Subject: Response to Technical Assistance Request
Bay Towel – Solvent Investigation, 501 S. Adams St, Green Bay, WI
BRRTS Activity # 02-05-237064, FID # 405044090

On October 18, 2021, the Wisconsin Department of Natural Resources (DNR) received a Technical Assistance Request entitled “Remedial Action Documentation Report, Groundwater Monitoring Status Report, and PFAS Sampling Report” (the Report) prepared by Matt Dahlem of Fehr Graham for the above referenced site. The appropriate \$700 technical assistance request fee for DNR review and response was submitted with the Report.

FIGURE 10
 POST-EXCAVATION GROUNDWATER
 CHEMISTRY – MAY 2021
 BAY TOWEL – SOLVENT INVESTIGATION
 501 S. ADAMS ST.
 GREEN BAY, WI 54301
 BRRTS NO.: 02-05-237064

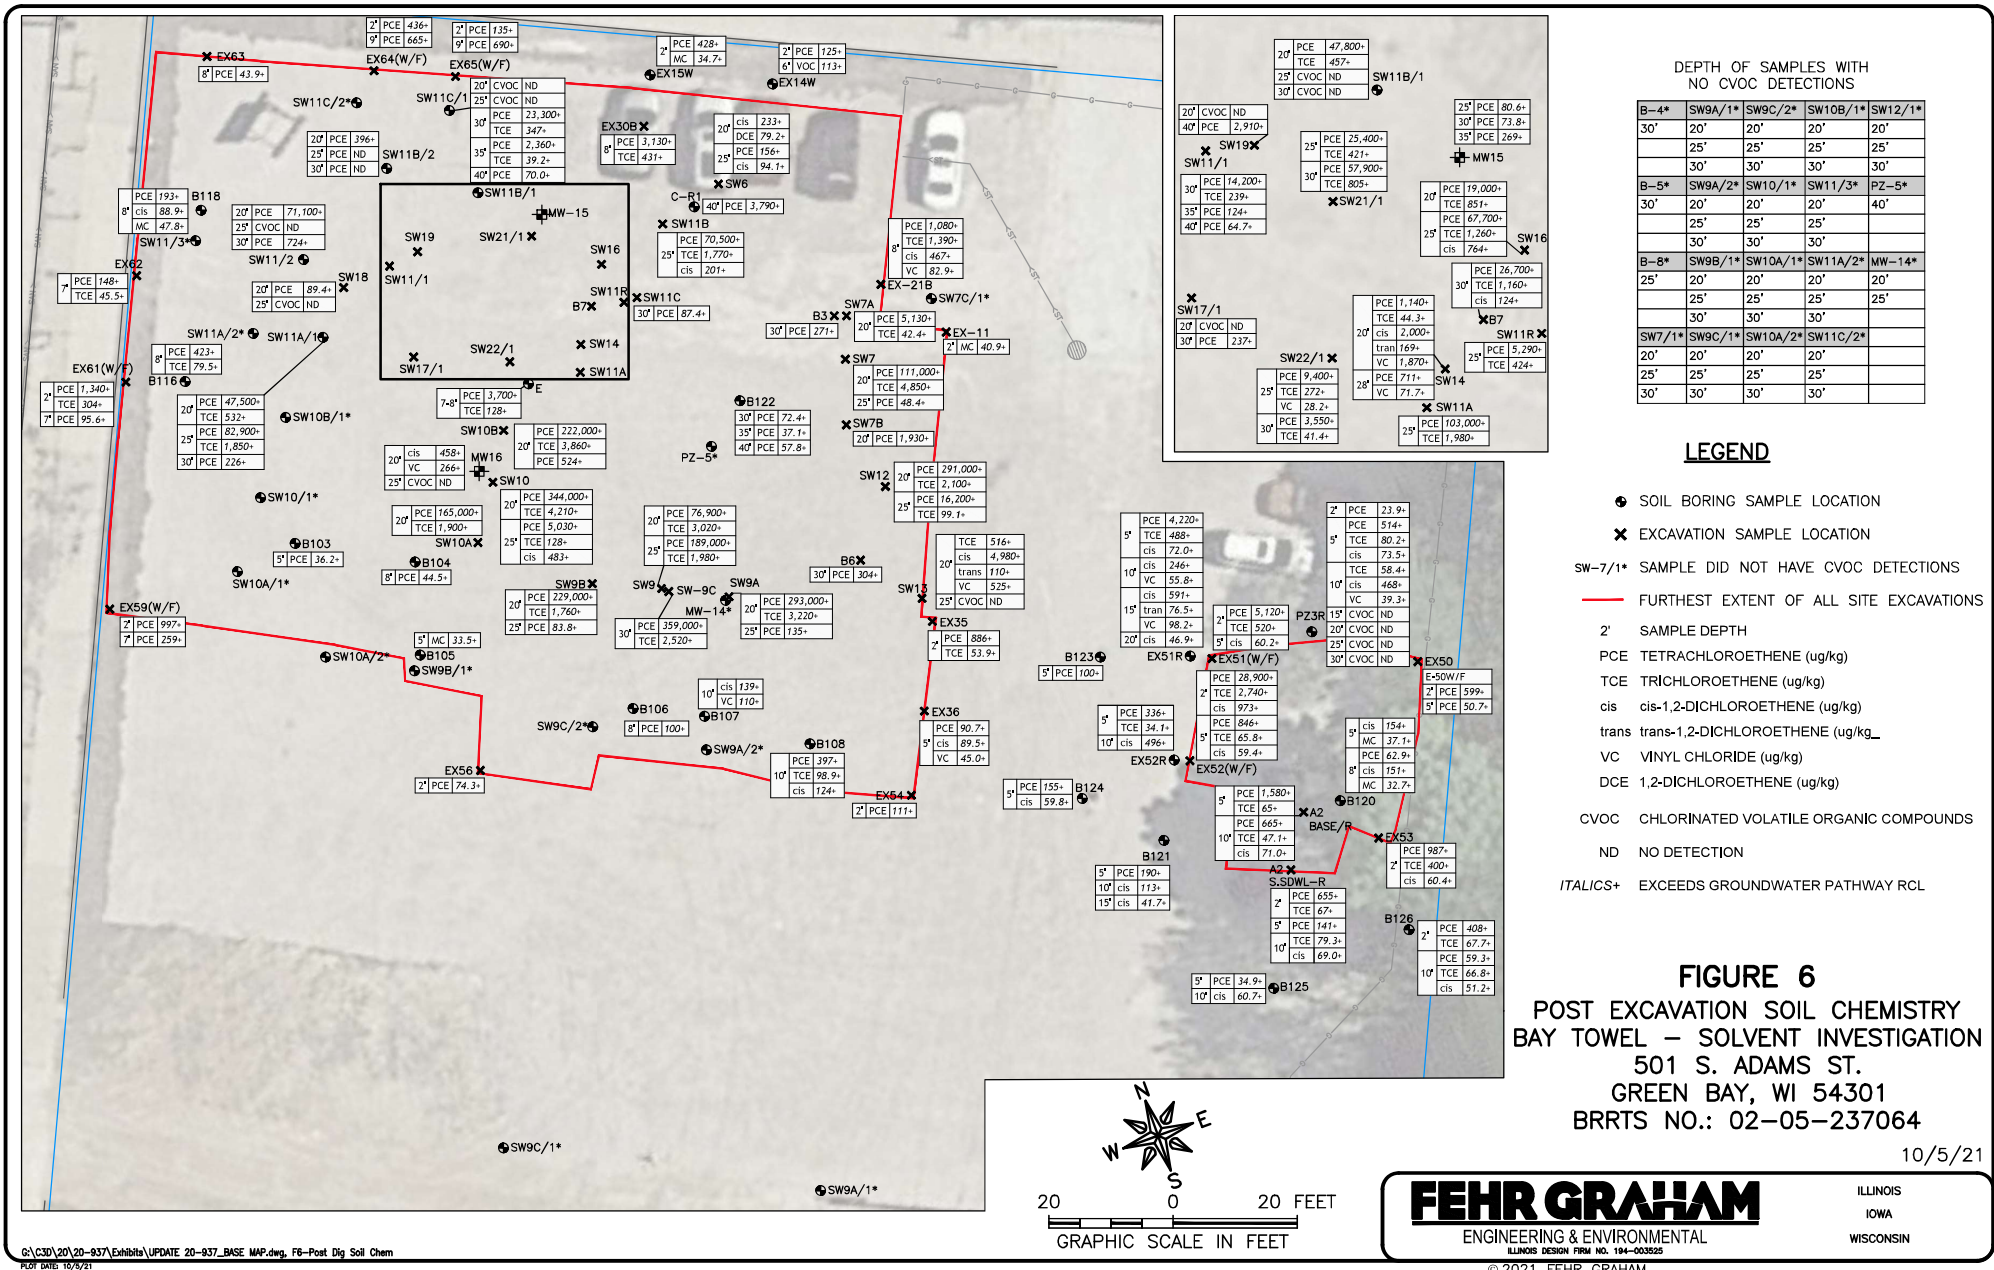
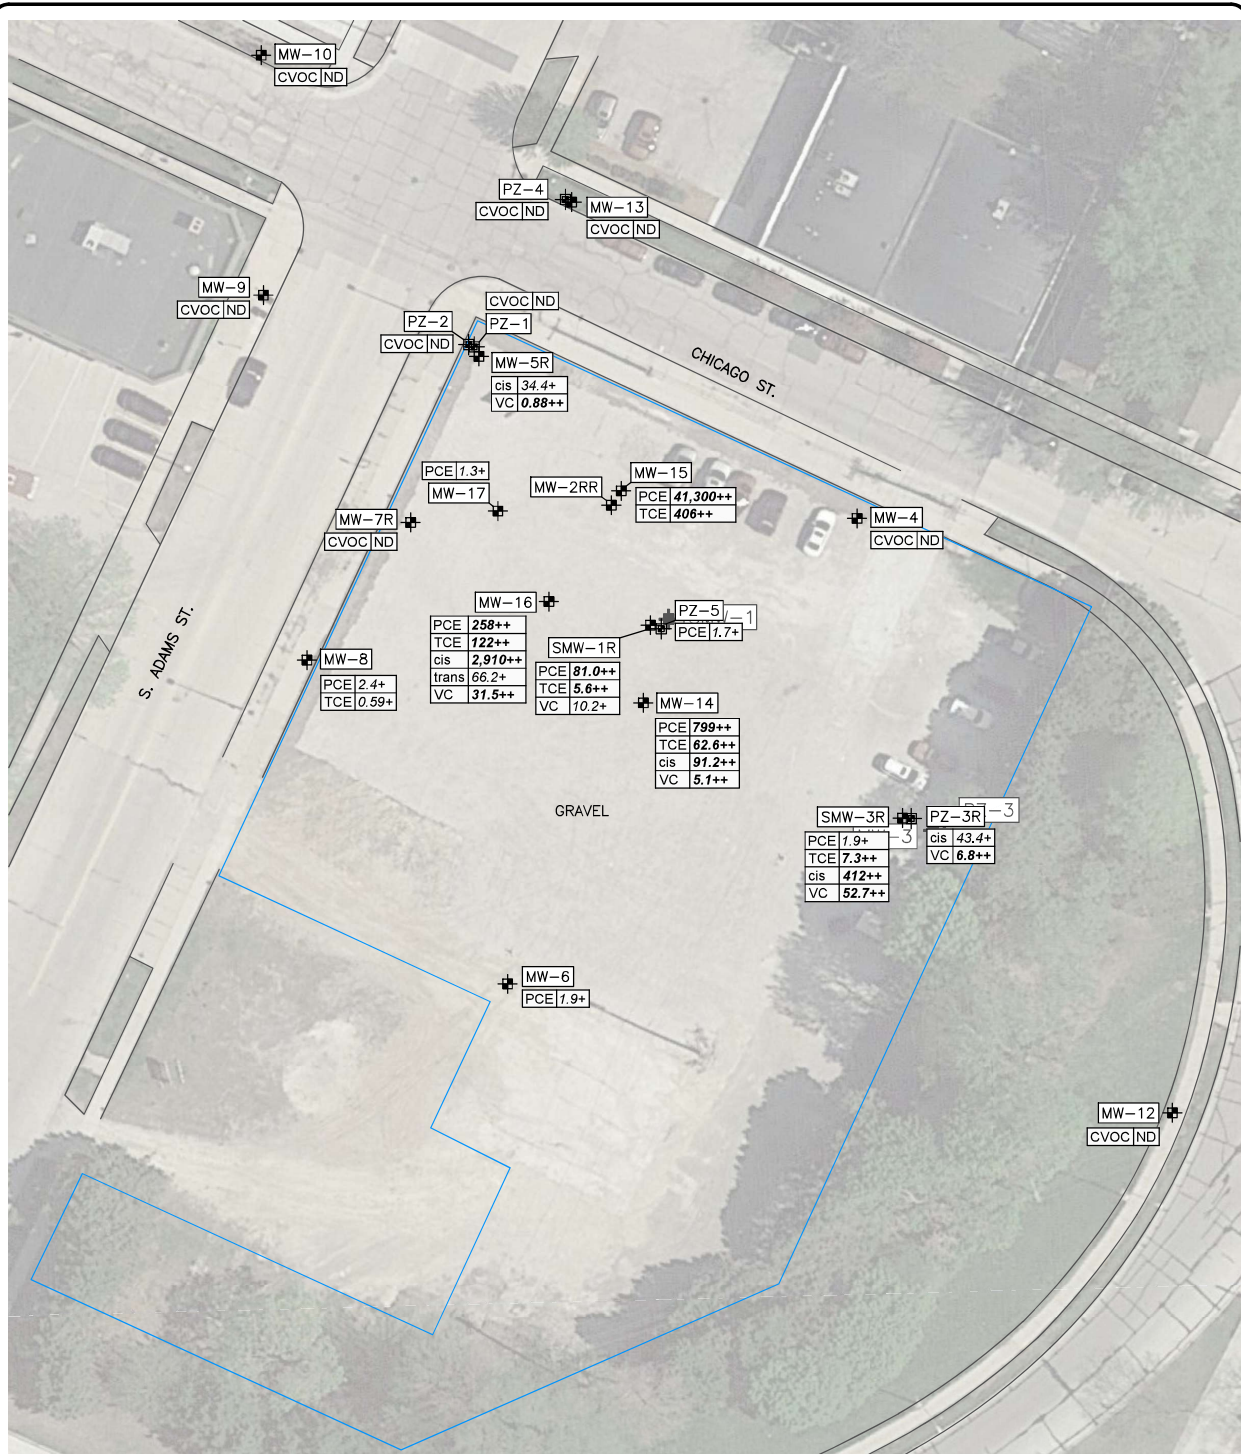
The degree and extent of groundwater contamination is not yet defined. During the latest excavation, elevated saturated soil contamination was discovered in sidewall samples within the interval of 20-30 feet bgs, and DNR advised that piezometer(s) be installed and screened within this interval. Monitoring MW-15 was installed after the excavation was filled in January 2021 and screened at 20-30 feet bgs. MW-15 was sampled twice in 2021 and detected 41,300 ug/L PCE in the latest round of sampling performed in May of 2021.

DNR is requiring further delineation of this monitoring well screened within the same vertical interval of 20-30 ft bgs to evaluate the extent, both vertically and horizontally, of groundwater contamination per Wis. Admin. Code § NR 716.11(5)(f). Additional rounds of post-remediation groundwater sampling are also required. The location of all current monitoring wells associated with the site, including MW-15, and post-excavation CVOC concentrations are shown on the attached map (Figure 10, Post-Excavation Groundwater Chemistry – May 2021, 10/5/21).

FIGURE 11
 PFAS GROUNDWATER
 CHEMISTRY – JUNE 2021
 BAY TOWEL – SOLVENT INVESTIGATION
 501 S. ADAMS ST.
 GREEN BAY, WI 54301
 BRRTS NO.: 02-05-237064

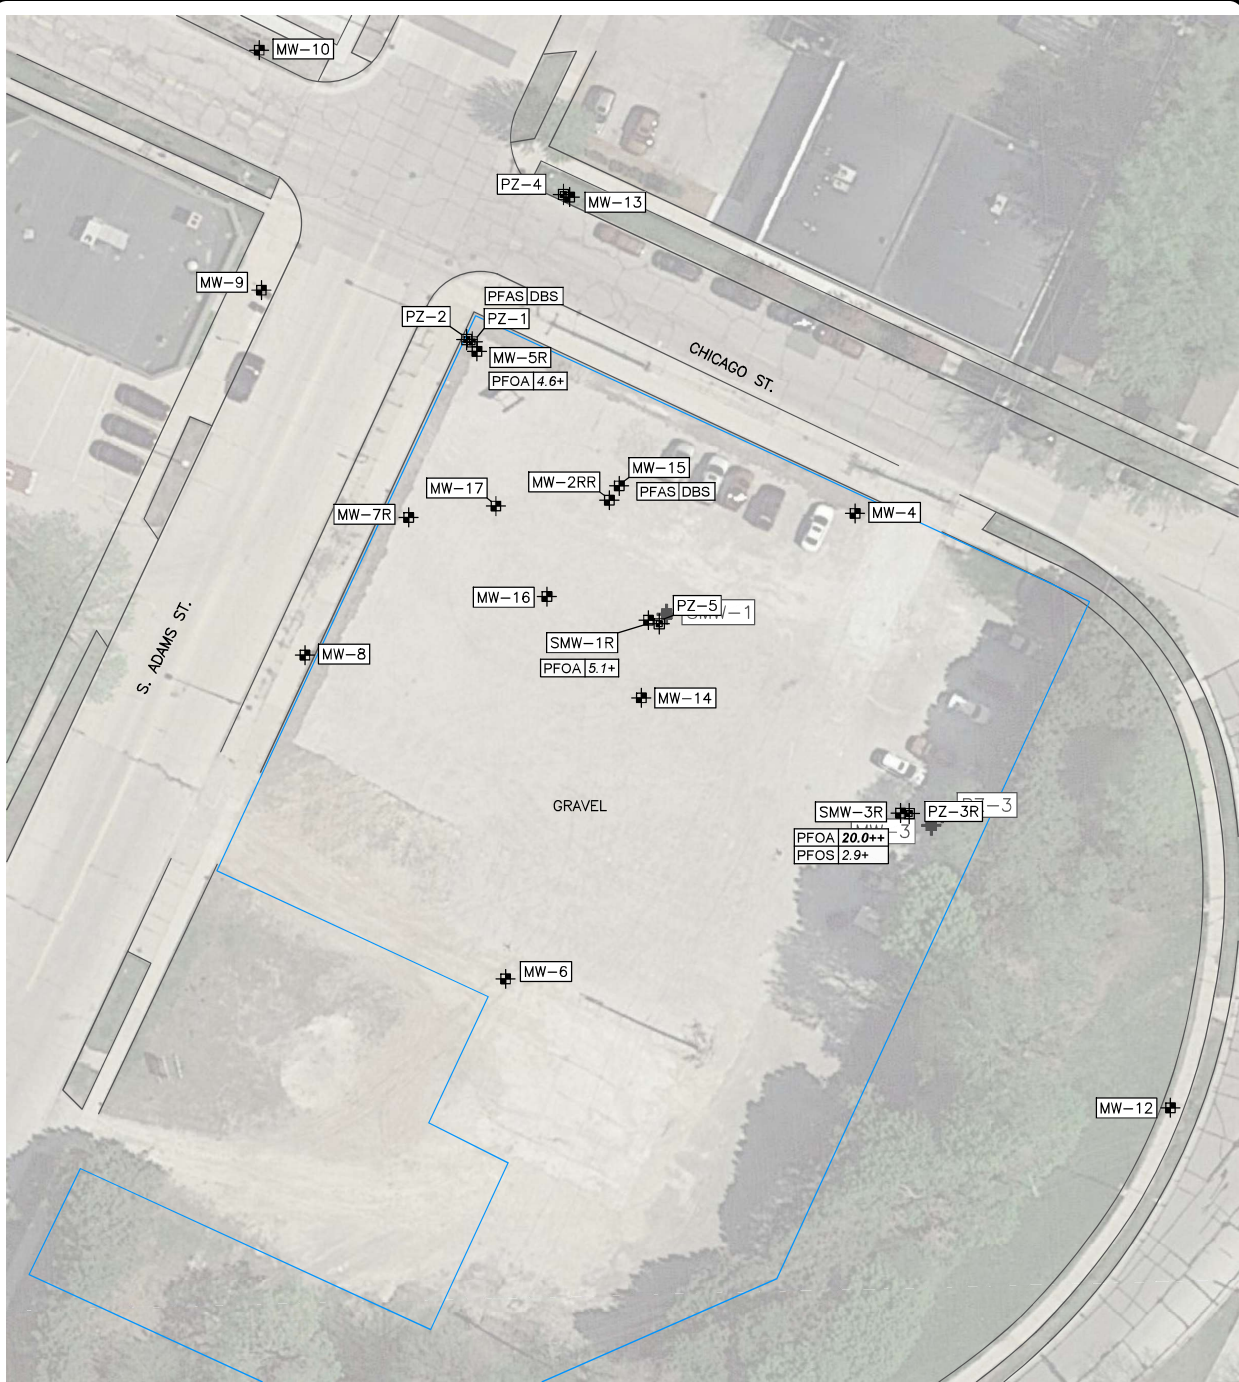
On January 2, 2020, DNR sent a letter requesting you sample for per- and polyfluoroalkyl substances (PFAS) at the Site; five monitoring wells were sampled on June 4, 2021 and are shown on the attached map (Figure 11, PFAS Groundwater Chemistry – June 2021, 10/5/21). Perfluoroactanoic Acid (PFOA) was detected in monitoring wells SMW-1R and MW-5R above the preventive action limit (PAL), and in SMW-3R above the enforcement standard (ES). DNR is requiring another round of PFAS sampling be performed at these same five wells to confirm PFAS contamination is stable and/or decreasing; a workplan needs to be submitted for sampling of these wells.
